PAGE AVJET CORPORATION		ORLANDO INTERNATIONAL AIRPORT 9809 TRANSPORT DRIVE ORLANDO, FLORIDA 32827	
DATE: 4/9/91	BY: [Signature]	TITLE: THE LIMITED 727-100 GENERAL ARRANGEMENT	
CHECKED: [Signature]	DATE: 7/2/91	PLOT: 1/1=30	DRAWING NO.
DESIGN: [Signature]	DATE: 4/9/91	FILE: A7201011	A727-0001-001
OTHER: [Signature]	DATE: 7/2/91	SCALE: NONE	SHEET 1 OF 1

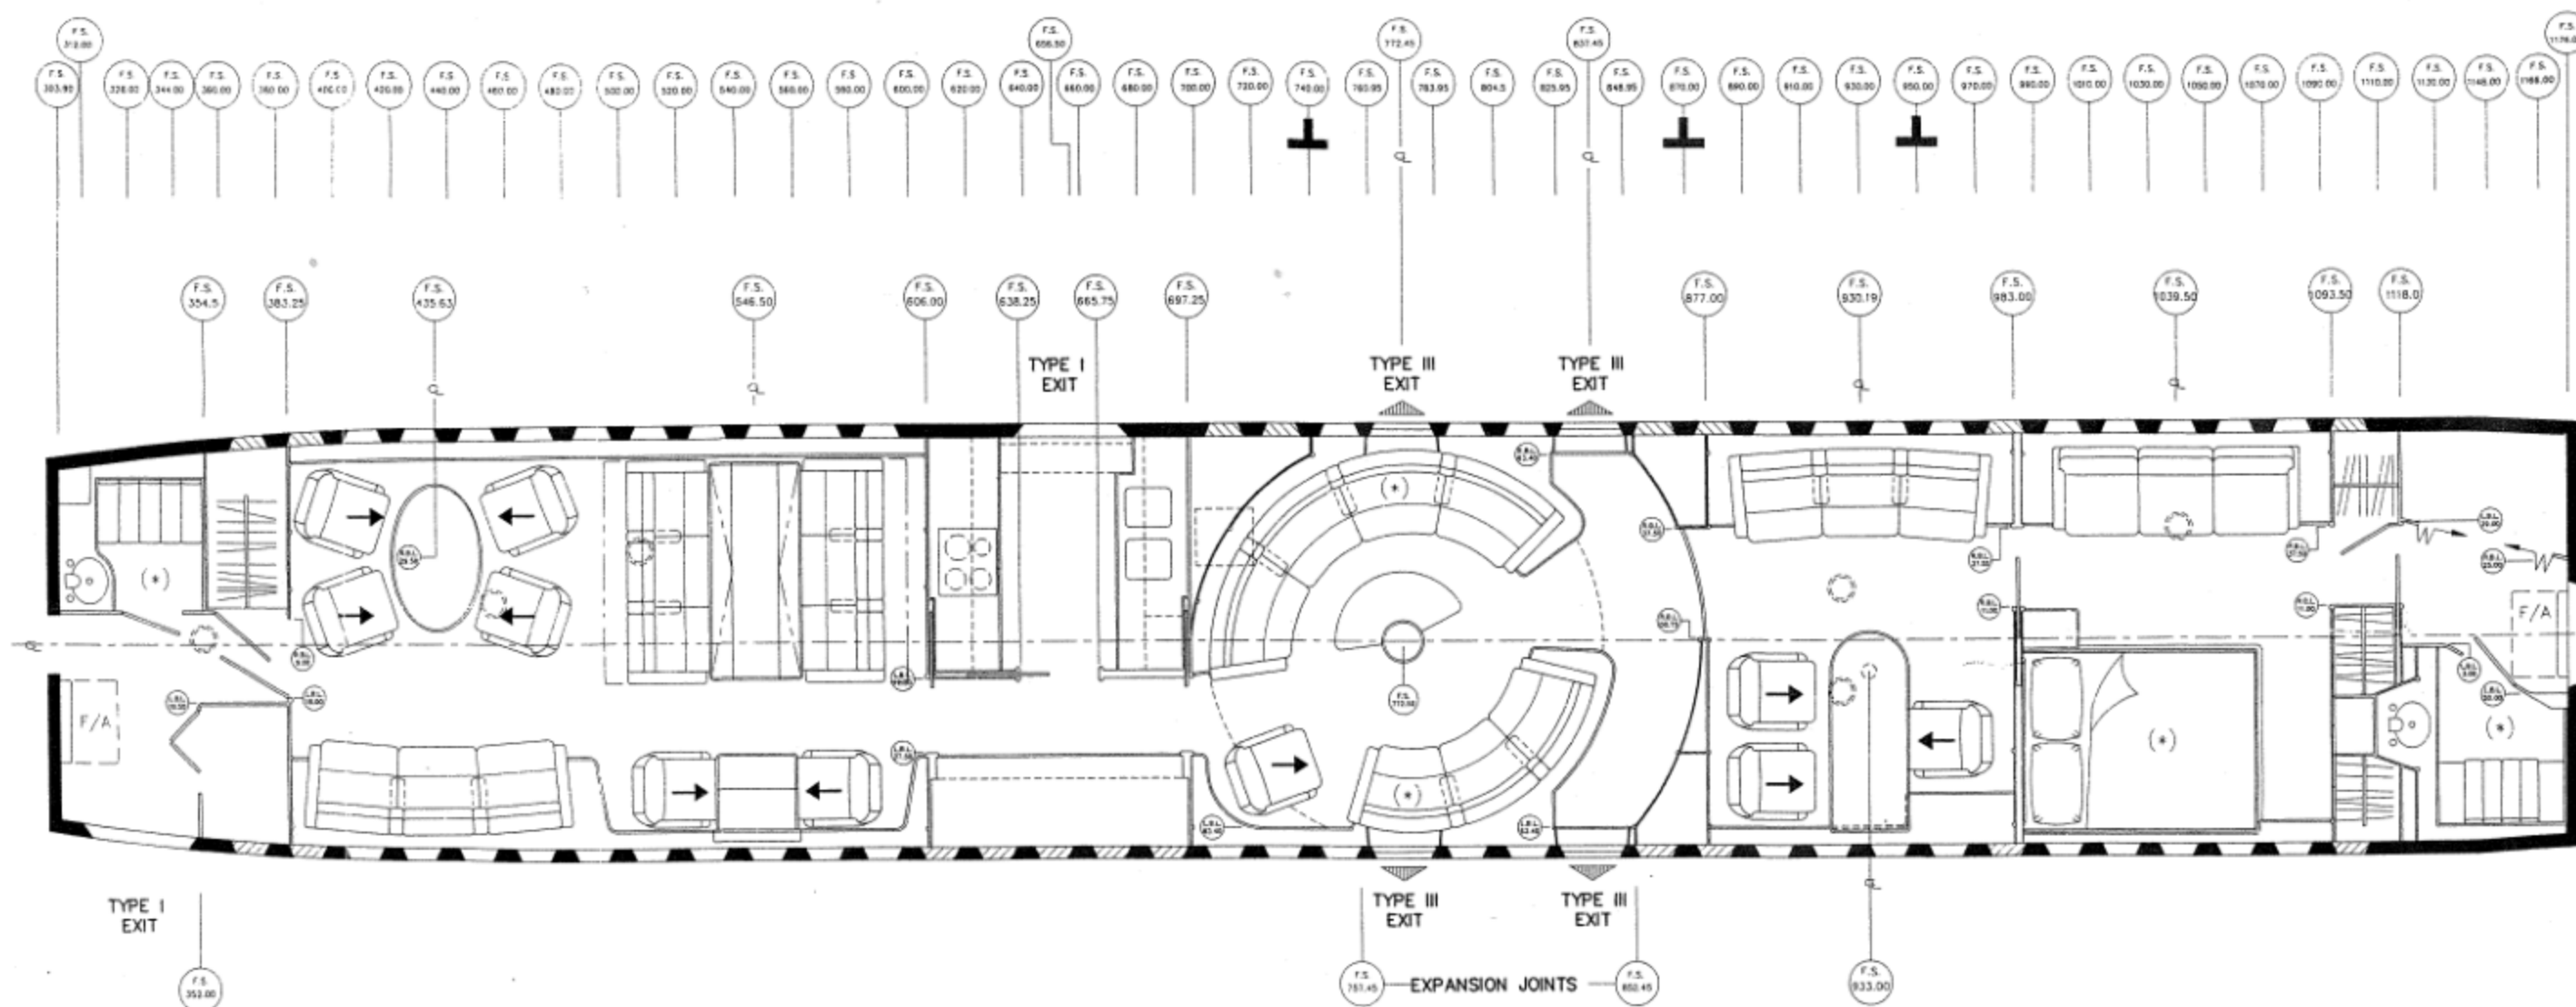
REVISIONS		
REV	DESCRIPTION	APP/DATE
A	GENERAL DRAWING UPDATE	FEB. 25, 91
B	RELOCATED FWD LOUNGE FWD BULKHEAD FROM FS 379.25 TO FS 383.25. PLUGGED RH & LH WINDOWS @ FS 380.00. CHANGED FWD RH DOUBLE GLOVE DOORS TO SINGLE FWD HINGED DOOR. RELOCATED CENTERLINE BL OF FWD RH TABLE FROM 32.00 TO 28.50.	APR. 9, 91
